UNITED STATES
 NUCLEAR REGULATORY COMMISSION
 REGION II
 101 MARIETTA STREET, N.W.
 ATLANTA, GEORGIA 30323

Report Nos.: 50-325/88-11 and 50-324/88-11

Facility Name: Brunswick 1 and 2

Inspection Conducted: February 29 - March 4, 1988 and March 14 - March 18, 1988

Figure 6.2

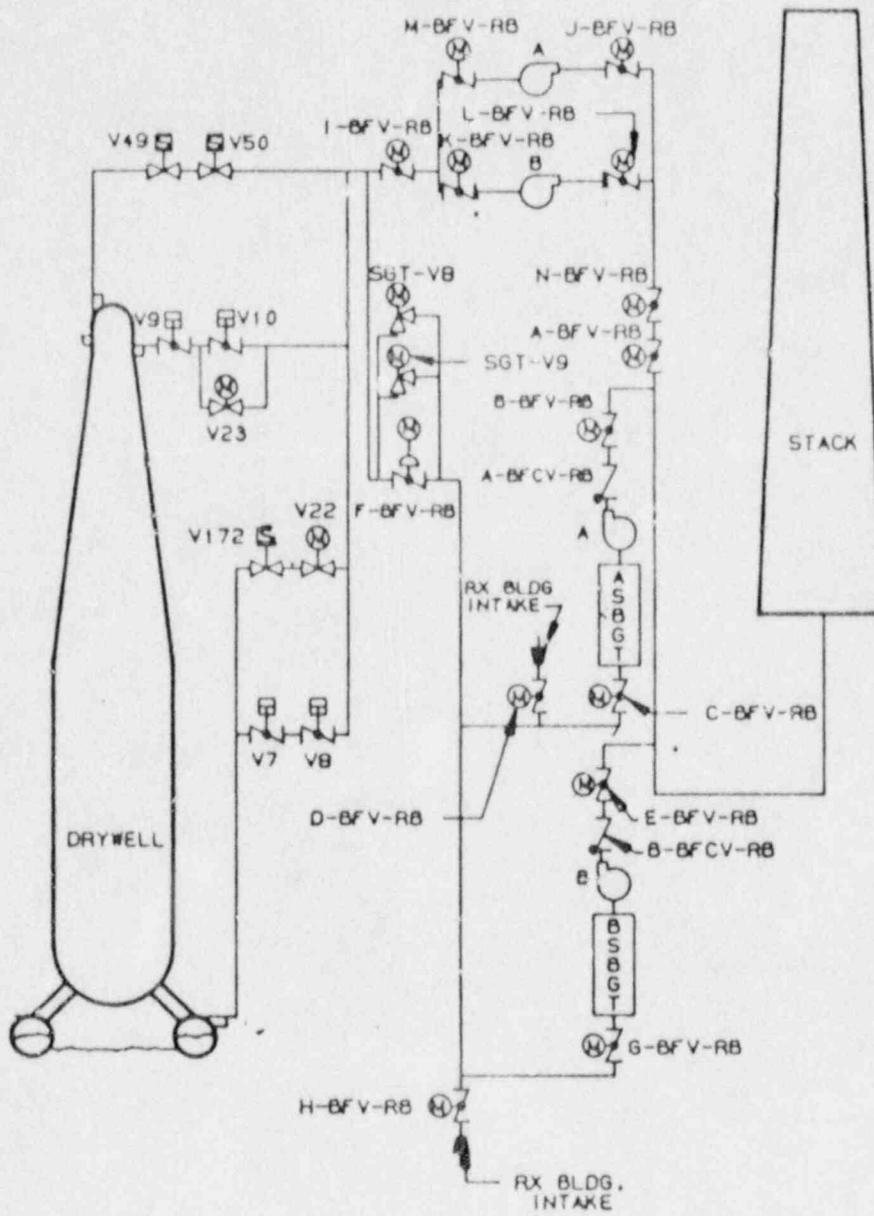
- As stated above, all planned venting actions are performed from the main control room. The licensee has not developed contingency actions should the initial attempt to vent fail. Manual operations of several of the valves would be prohibitive due to their location and the expected radiation levels during an accident.

- The entire vent path is hard piping with the exception of a small section of duct at the purge exhaust fans. This duct contains what appears to be field fabricated expansion joints on each side of the fans that would be susceptible to failure during a vent. The licensee agreed with this comment and could not provide a design pressure rating for the joints.

- Development of a system model to determine the worst case flow and pressure in the vent path has been initiated but not yet completed. The completion of the model should enable a better understanding of the system performance and limitations. The inspector reviewed a preliminary analysis that indicated adequate venting could be achieved with a minimal pressure surge in the vent path by partially opening only the large suppression chamber butterfly valves (V7 & V8). This would have the added advantage of accomplishing all venting from the suppression pool. The preliminary results also indicated that relatively high pressures (approximately 40 psig) may be experienced at the purge exhaust fans during certain system configurations. A review of the final system model and the resulting system performances will be the subject of further inspection and is identified as an Inspector Followup Item 324,325/88-11-01, Vent Path Model.
